In page 529, line 47, correct section 8.4.9.2.3.1 as shown below:

8.4.9.2.3.1 CTC encoder

In page 532, line 40, correct the text as shown below:

Figure 240—CTC encoder

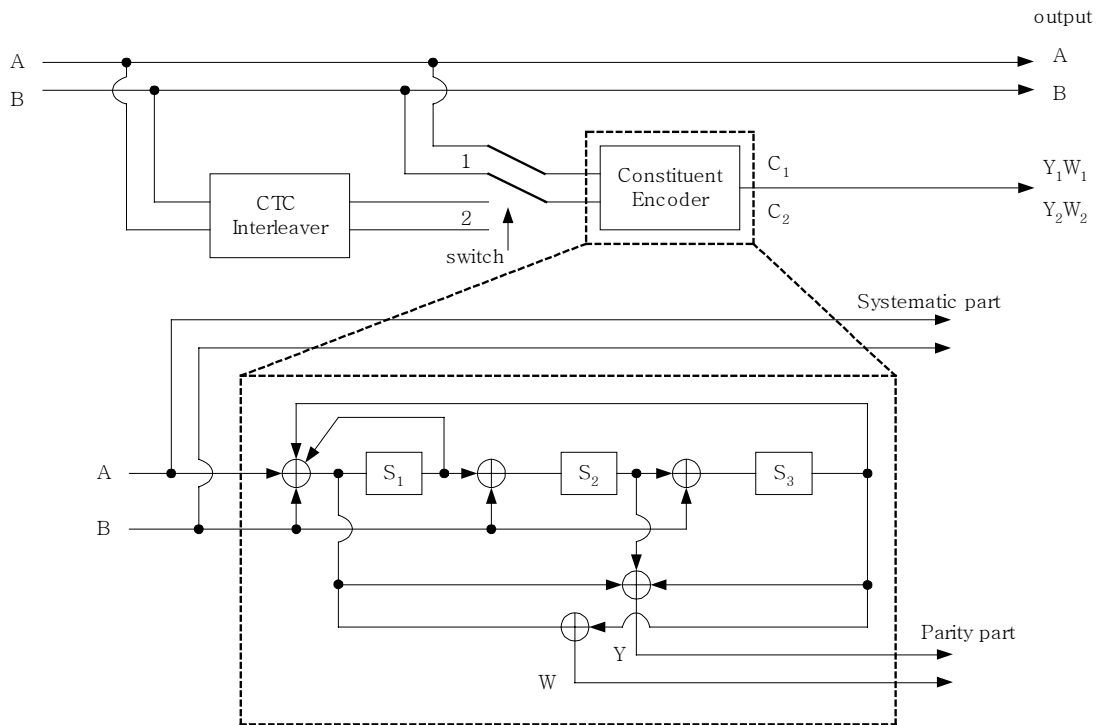
The Convolutional Turbo Code defined in this section is designed to enable support of hybrid ARQ (H-ARQ). H-ARQ implementation is optional. The Convolutional Turbo Code encoder, including its constituent encoder, is depicted in Figure 240. It uses a double binary Circular Recursive Systematic Convolutional code. The bits of the data to be encoded are alternately fed to A and B, starting with the MSB of the first byte being fed to A. The encoder is fed by blocks of k bits or N couples (k = 2*N bits). For all the frame sizes k is a multiple of 8 and N is a multiple of 4. Further N shall be limited to: 8 ≤ N/4 ≤ 1024.

First, the encoder (after initialization by the circulation state S_{c1} , see 8.4.9.2.3.3) is fed the sequence in the natural order (position 1) with the incremental address $i = 0 .. N-1$. This first encoding is called S_{c1} encoding. Then the encoder (after initialization by the circulation state S_{c2} , see 8.4.9.2.3.3) is fed by the interleaved sequence (switch in position 2) with incremental address $j = 0, \dots, N-1$. This second encoding is called C_2 encoding.

The order in which the encoded bit shall be fed into the [interleaver \(8.4.9.3\)](#) [subpacket generation block \(8.4.9.2.3.4\)](#) is:

Figure 245— Block diagram of the interleaving scheme

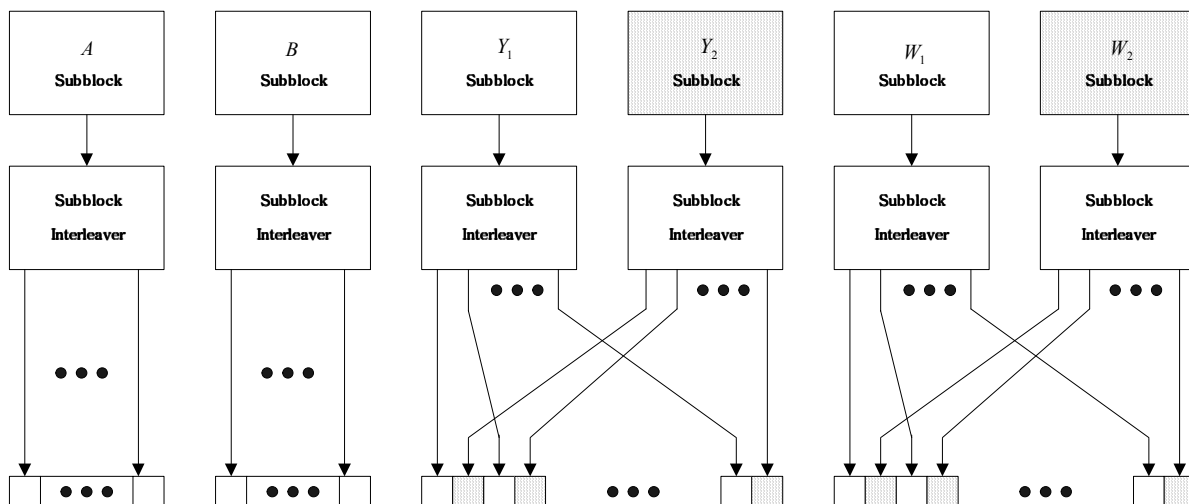
Proposed FEC structure punctures the mother codeword to generate subpacket with various coding rates. The subpacket is also used as H-ARQ packet transmission. Figure ~~bbb~~244 shows block diagram of subpacket generation. 1/3 CTC encoded codeword goes through interleaving block and the puncturing is performed. Figure 245 shows block diagram of the interleaving block. The puncturing is performed to select the consecutive interleaved bit sequence that starts at any point of whole codeword. For the first transmission, the subpacket is generated to select the consecutive interleaved bit sequence that starts from the first bit of the systematic part of the mother codeword. The length of the subpacket is chosen according to the needed coding rate reflecting the channel condition. The first subpacket can also be used as a codeword with the needed coding rate for a burst where H-ARQ is not applied.

All of the encoded symbols shall be demultiplexed into 6 subblocks denoted A, B, Y_1, Y_2, W_1 and W_2 . The encoder output symbols shall be sequentially distributed into 6 subblocks with the first encoder output symbols going to the A subblock, the second encoder output going to the B subblock, the third to the Y_1 subblock, the fourth to the Y_2 subblock, the fifth to the W_1 subblock, the sixth to the W_2 subblock, etc.

The six subblocks shall be interleaved separately. The interleaving is performed by the unit of symbol. The sequence of interleaver output symbols for each subblock shall be generated by the procedure described below. The entire subblock of symbols to be interleaved is written into an array at addresses from 0 to the number of the symbols minus one ($N-1$), and the interleaved symbols are read out in a permuted order with the i -th symbol being read from an address, $AD_i (i = 0 \text{ to } N - 1)$, as follows:
